SCHEDULE "A"
Site Plan Control Agreement
Pirelli Cables

STORMWATER MANAGEMENT DESIGN BRIEF

Re: **Site Plan Control Application Review**
Roll No. 070170102009906

We herein submit our response to South Nation Conservation comments dated – May 13, 2021 for the proposed Expansion at Prysmian Cables in Prescott, ON. We have reviewed these comments and have made some modifications to the stormwater design as discussed below. In some cases, we respectfully offer differing opinions to the SNC comments.

ENLARGED GRADING & DRAINAGE PLAN			
CHECKED BY:	DATE:	CONTRACT NO.	8206
DESIGNED BY:		DRAWING NO.	SP-03
DRAWN BY:	DSS	REVISION NO.	B
SCALE:	1:500 (metric)

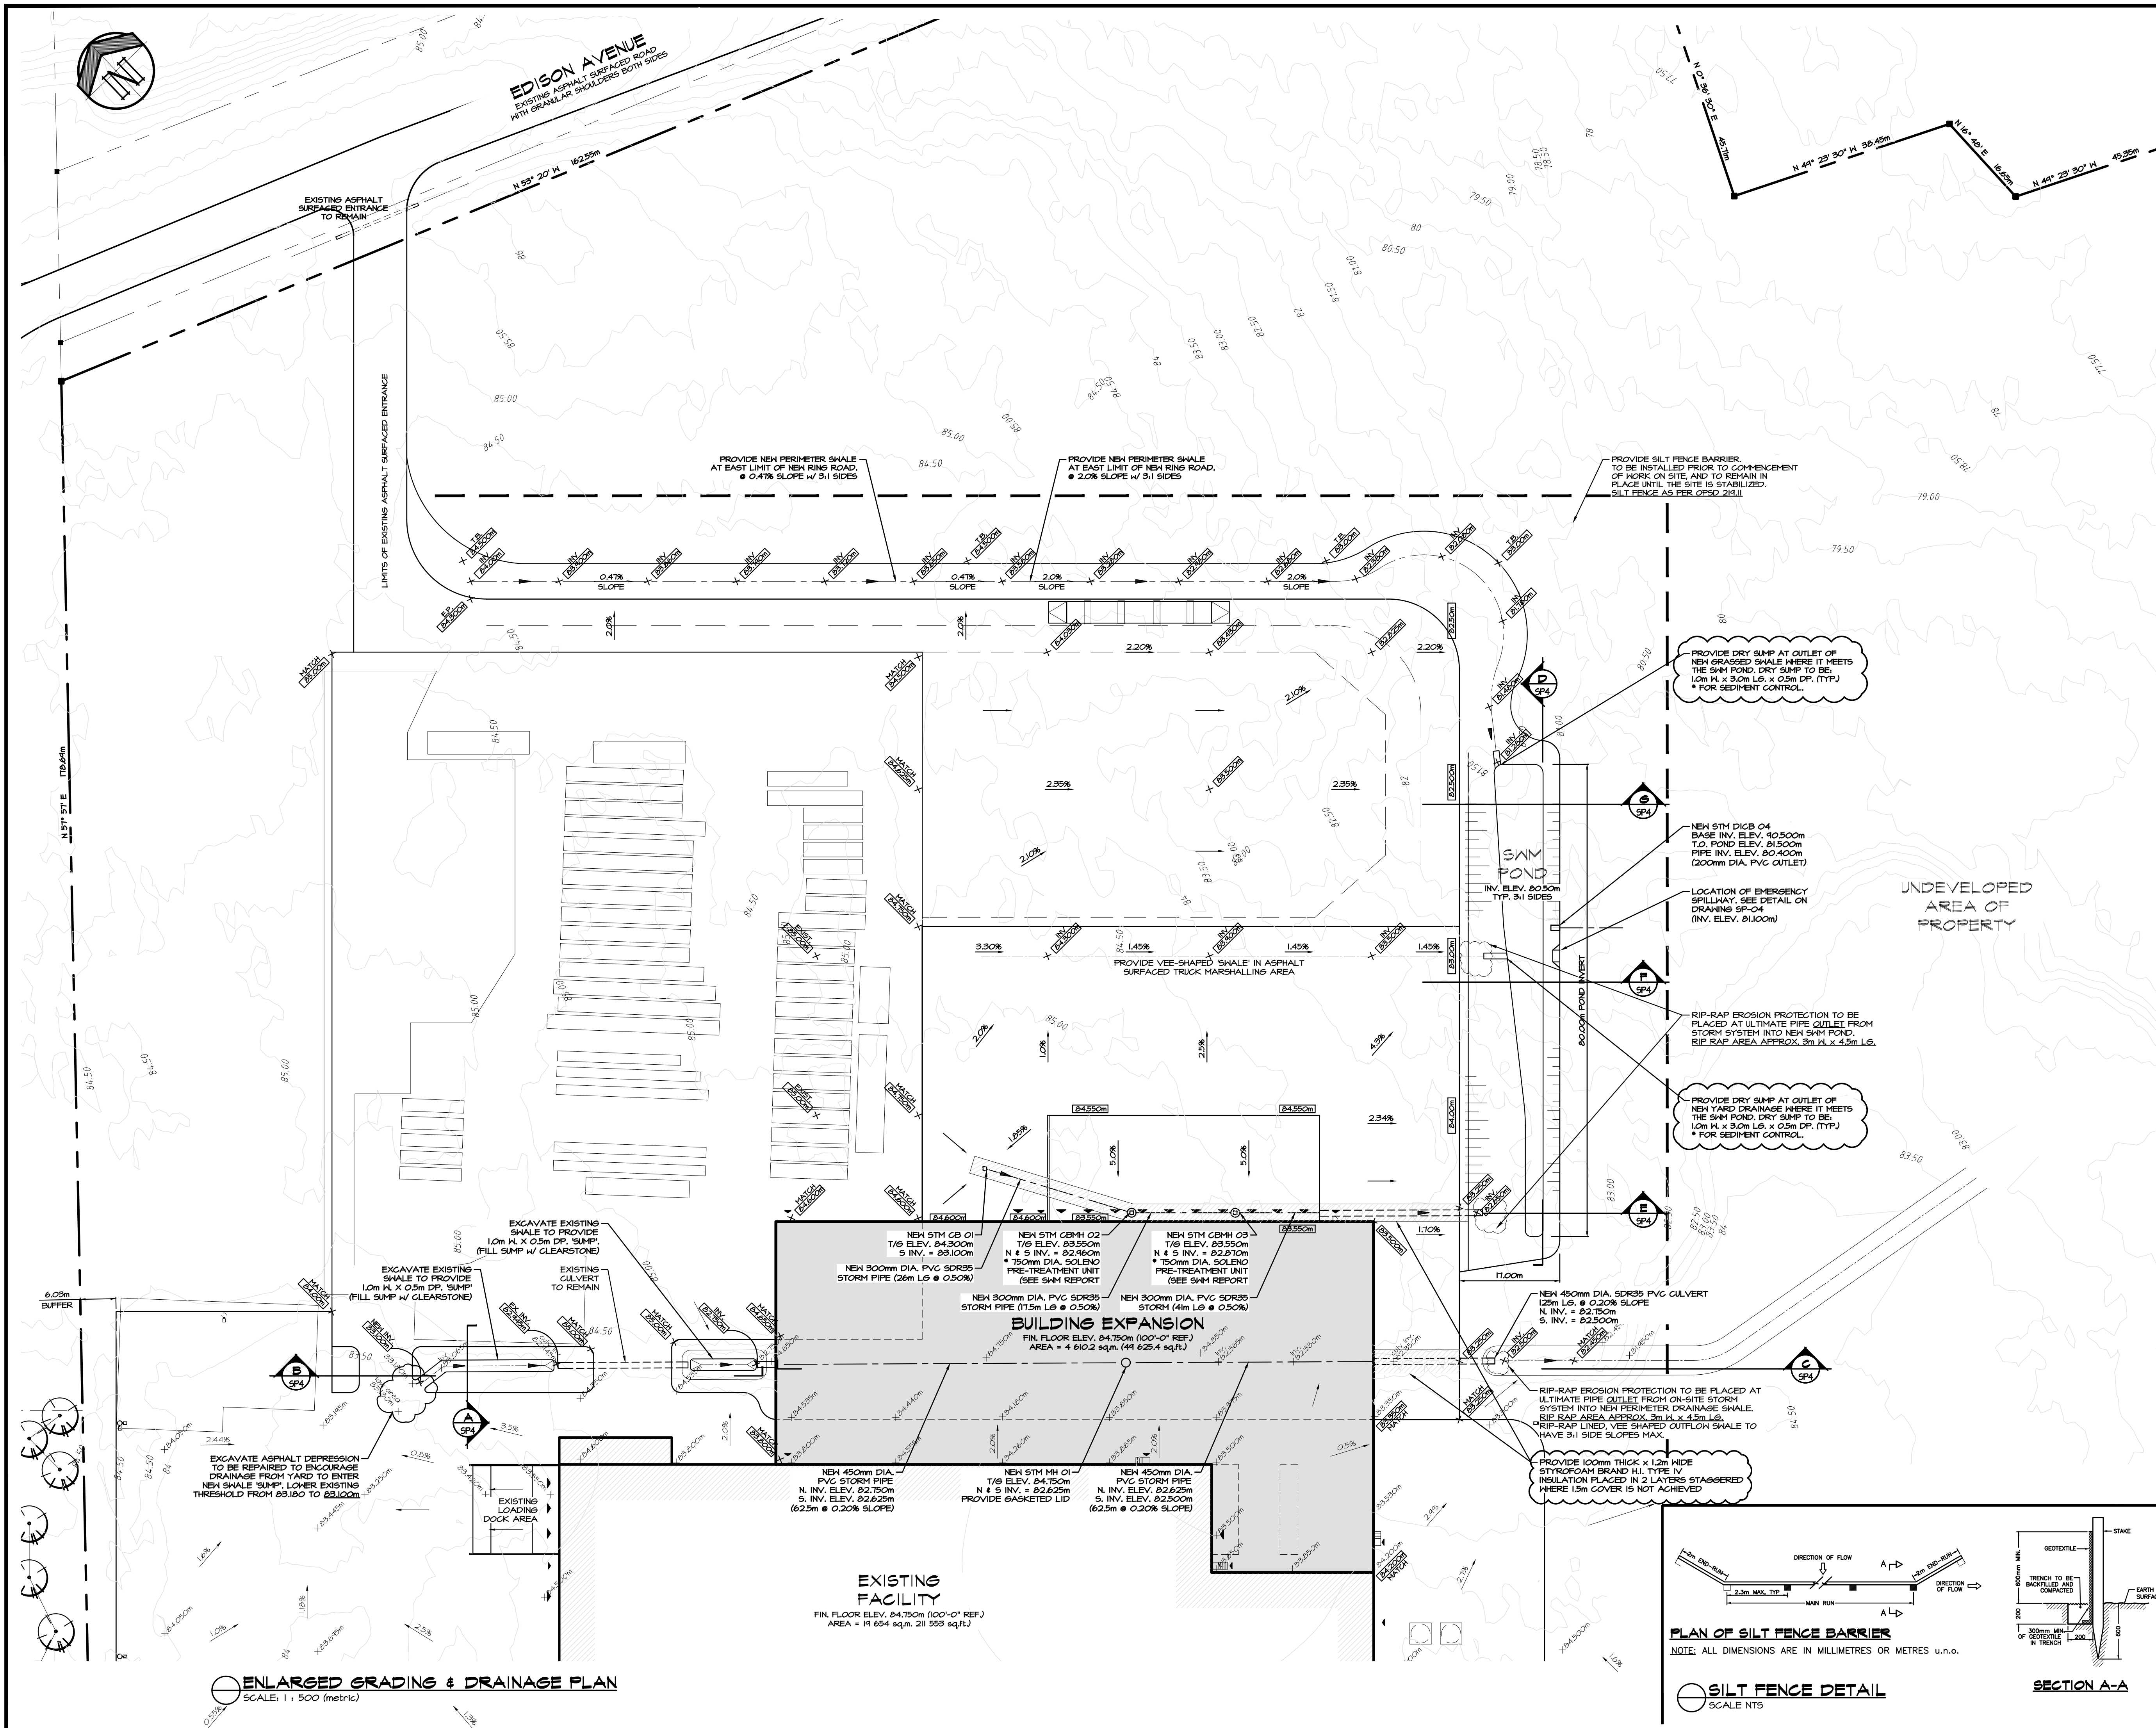
Comment 1

The first comment was regarding the legal outlet for the drainage from the site. The site drains directly to King Street East which is a legal outlet. We have updated our site plan drawings to show overland flow on the site to the legal municipal ditch running parallel to the King Street East.
